MY2 MONITORING REPORT - Stream Mitigation

STRAWBERRY HILL MITIGATION PROJECT

Subject: DMS Comments on the MY2 Report
Strawberry Hill, Project ID #100094, DMS Contract 7745

RE: DMS Comments on the MY2 Report Strawberry Hill, Project ID #100094, DMS Contract 7745

Figure 2a - CCPV MY2 2023
Strawberry Hill Mitigation Project
 Johnston County, North Carolina

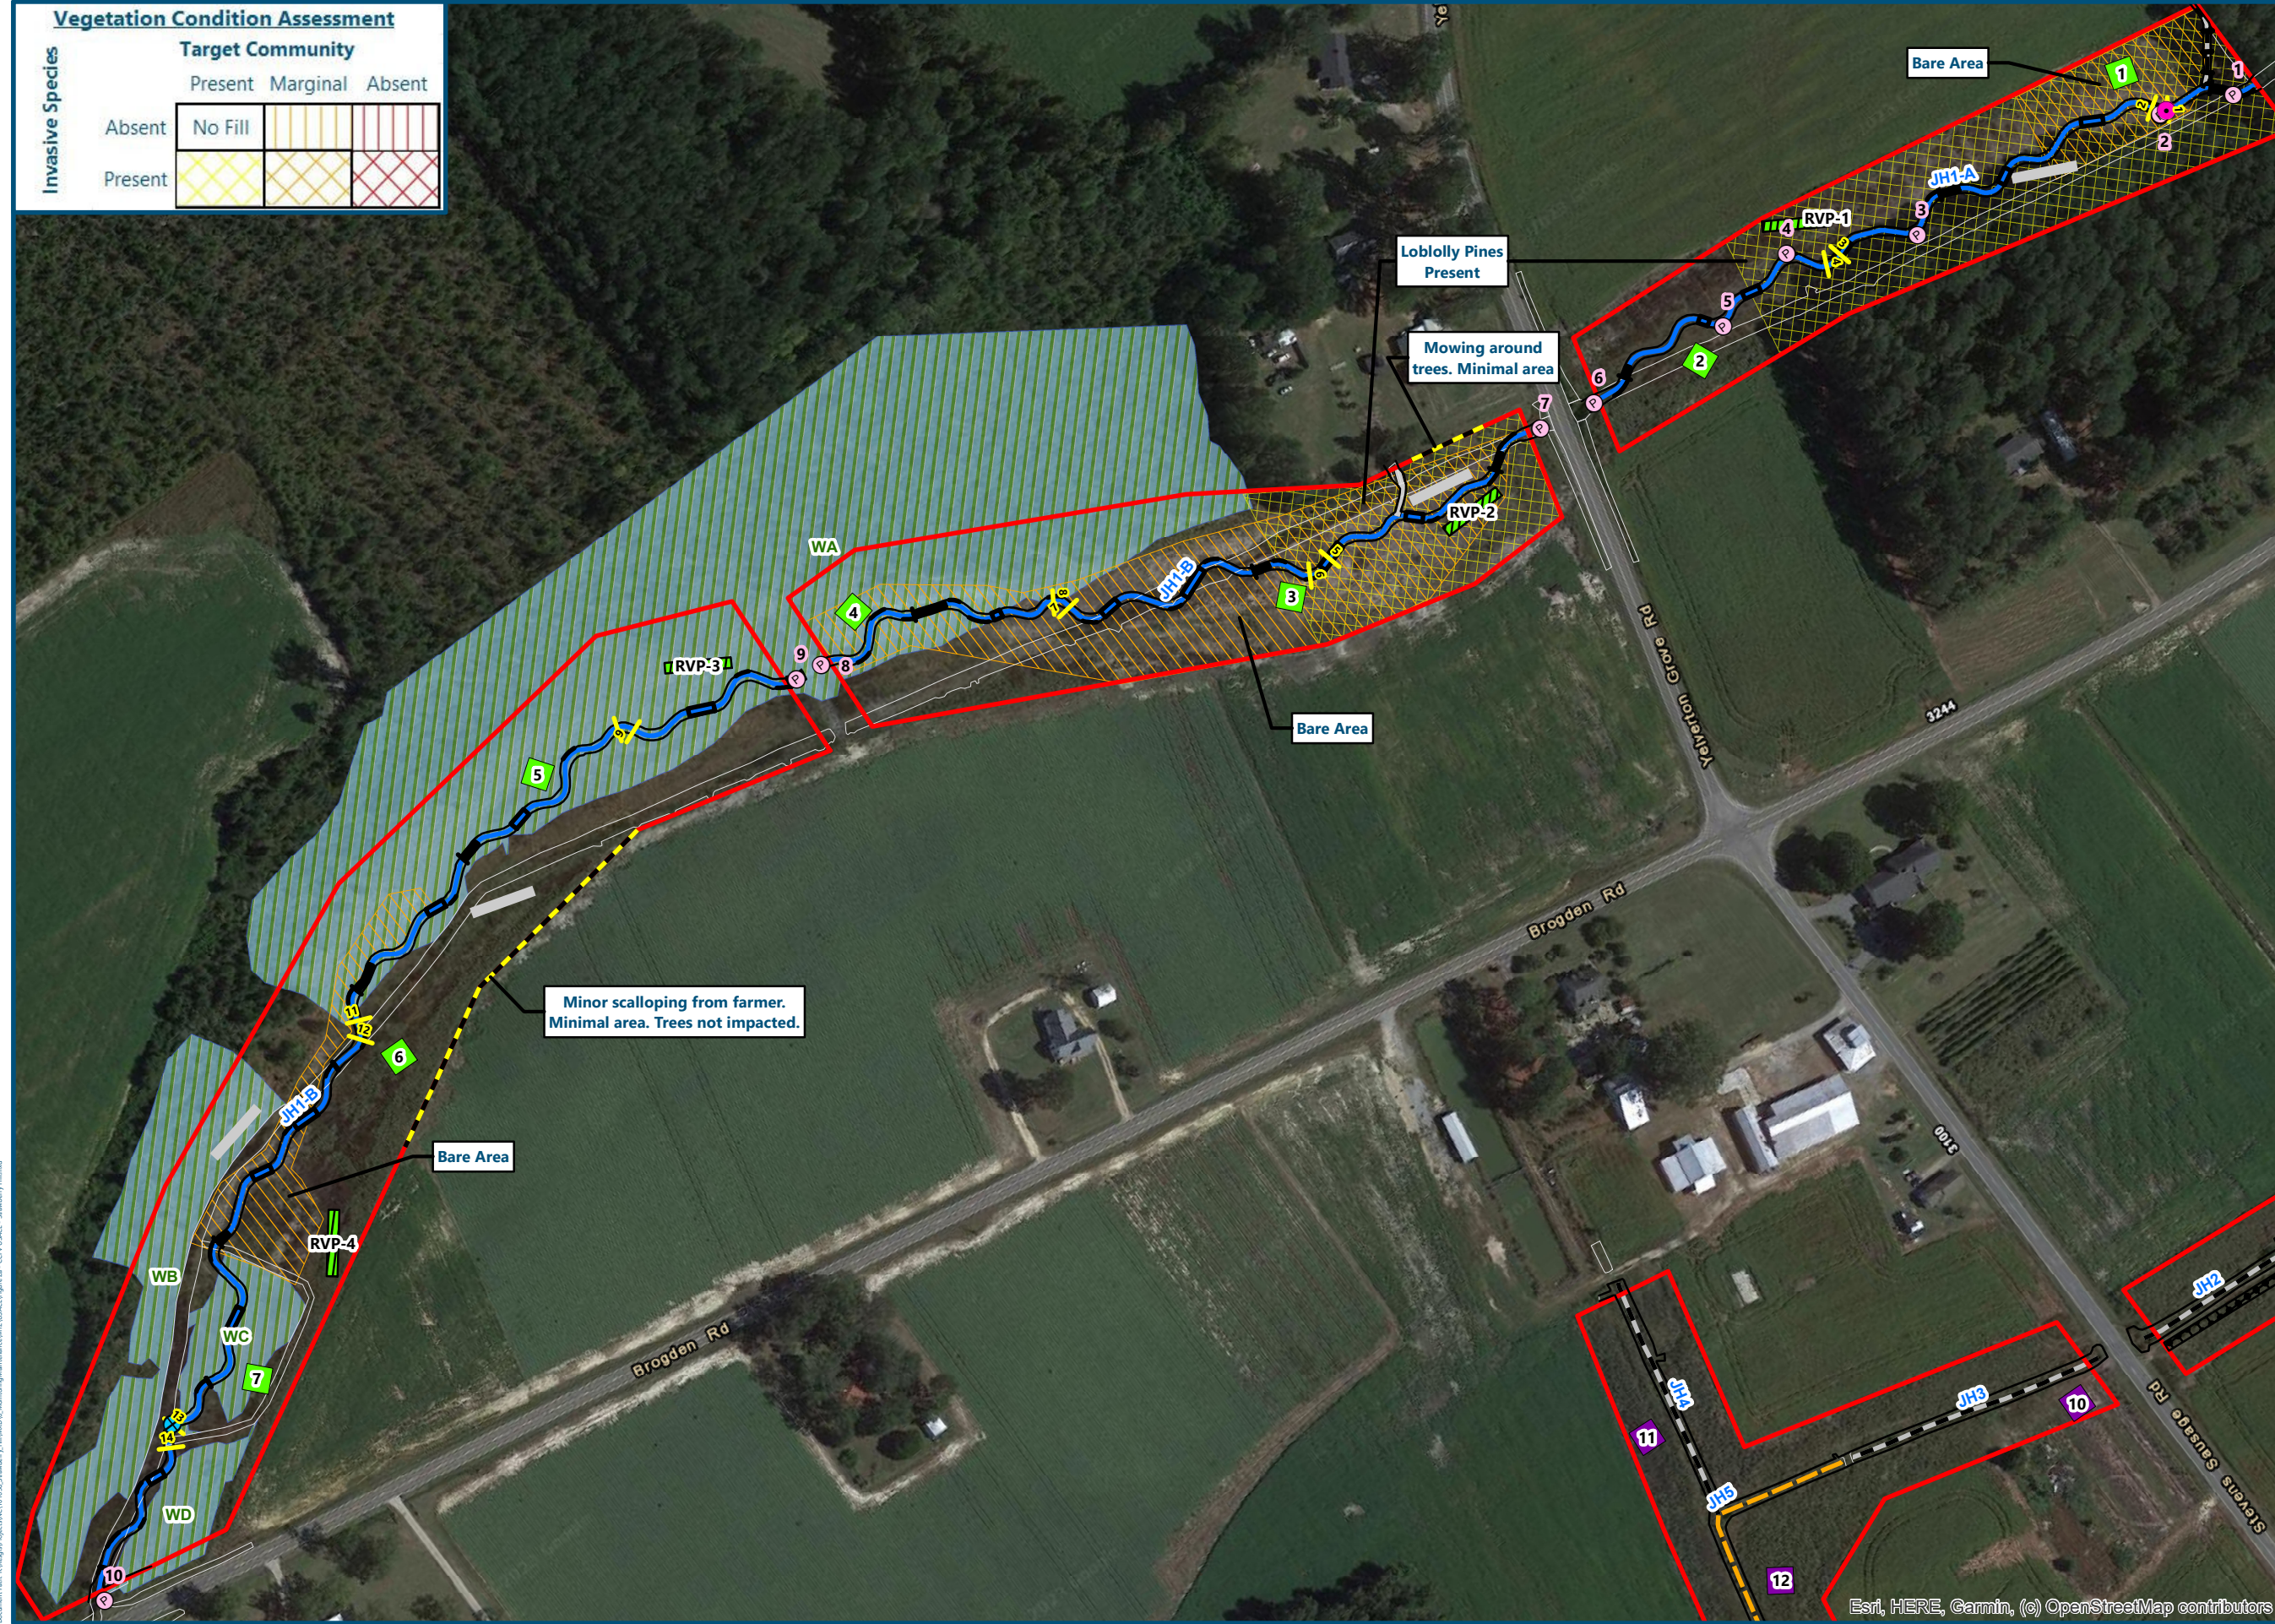
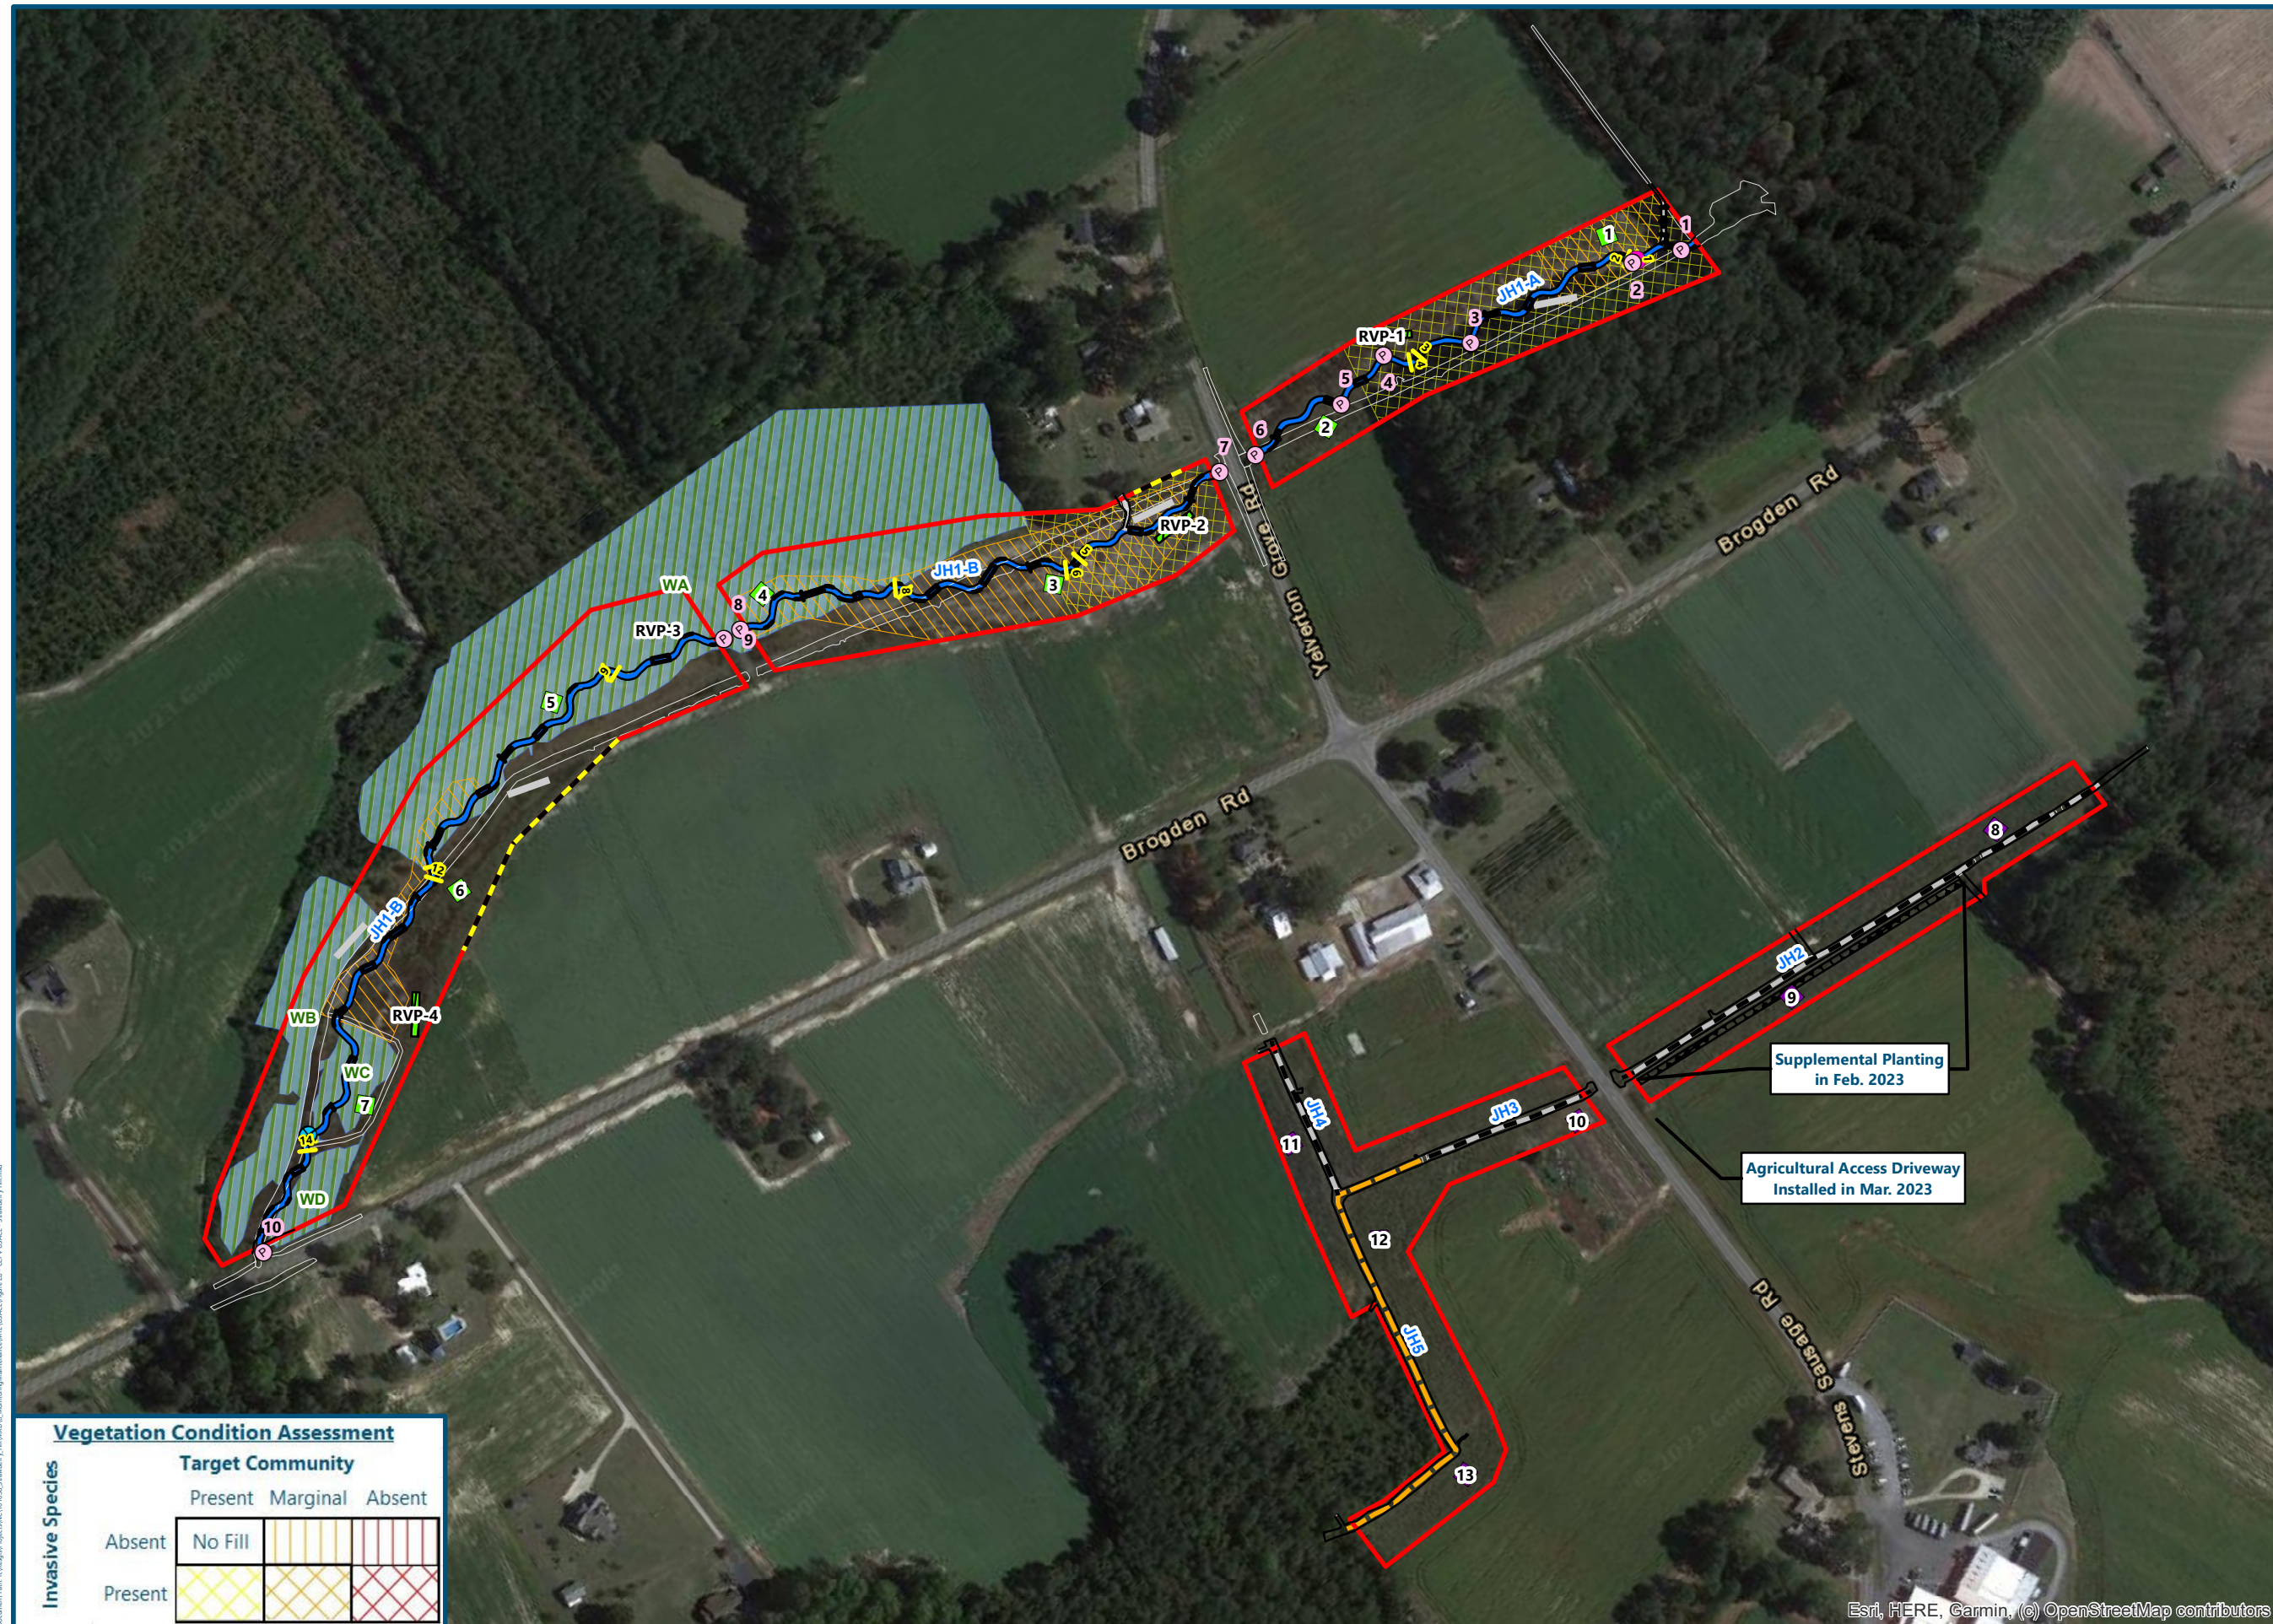
4. A few minor encroachments (scalping) were identified during the 11/30 site visit. Please add these areas to the CCPV and indicate how future encroachments will be prevented in these areas. The CCPV has been revised to include these areas and discussion has been added to **Section 1.5.1**. The encroachments are very small and narrow and do not appear to result in any tree mortality. The areas are mapped as lines as the areal coverage is minimal.

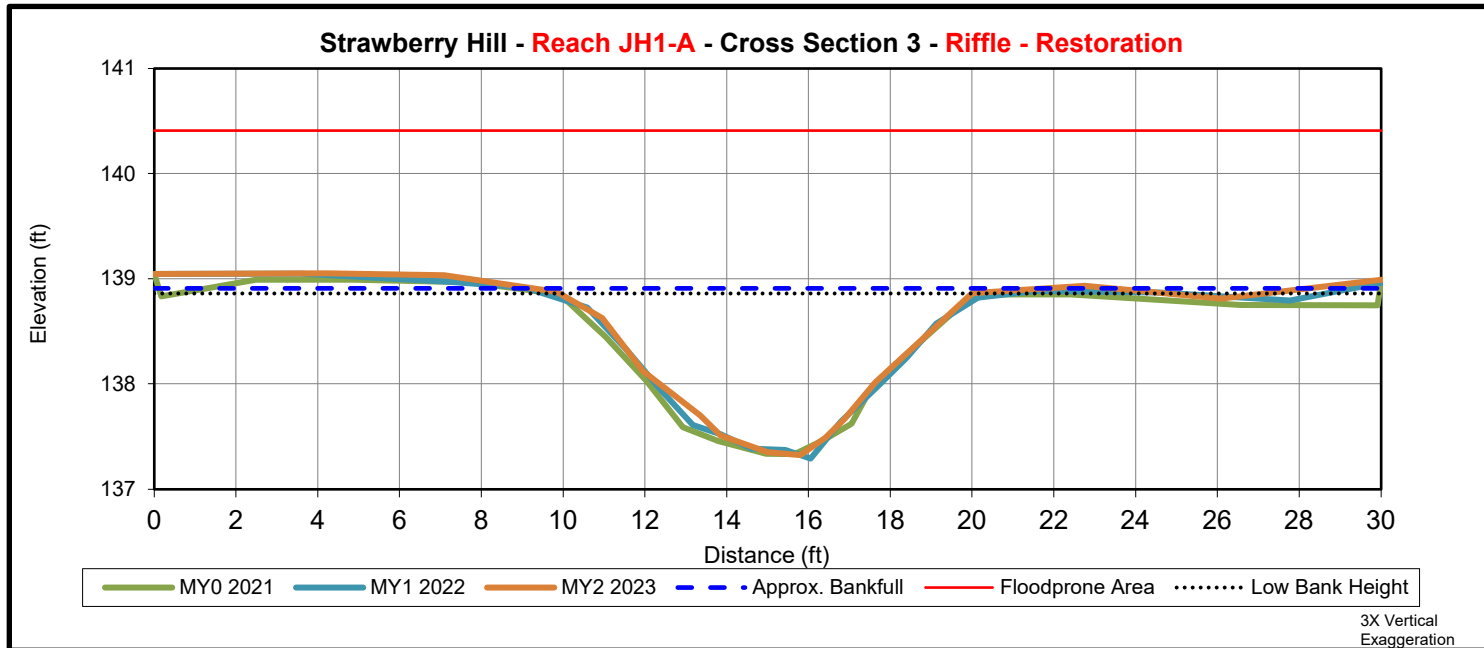
3. Please review cross sections. Some cross section BHRs are not reproducible with the numbers in the report. For example, XS-3 calculates to a 0.95 BHR based on report numbers (using formula *LTOB Max Depth / [BKFL Elev. Based on MY0 XSA – Thalweg Elevation]*) but is reported as 1.00. Reviewing the submitted Excel data (again using XS-3 as an example) to remove possibility of rounding errors produces similar results. We can reproduce all MY1 BHRs with the method described above.

[BHRs and Max Depths have been revised for all cross sections and respective morphology tables have been updated. The discrepancy stemmed from entering rounded numbers in the morph tables instead of the raw calculations. Then, the formulas in Table 11 Morphology data table were overwritten with the rounded calculations. These issues have been corrected and the updated calculations for BHR and Max Depth are accurate.](#)
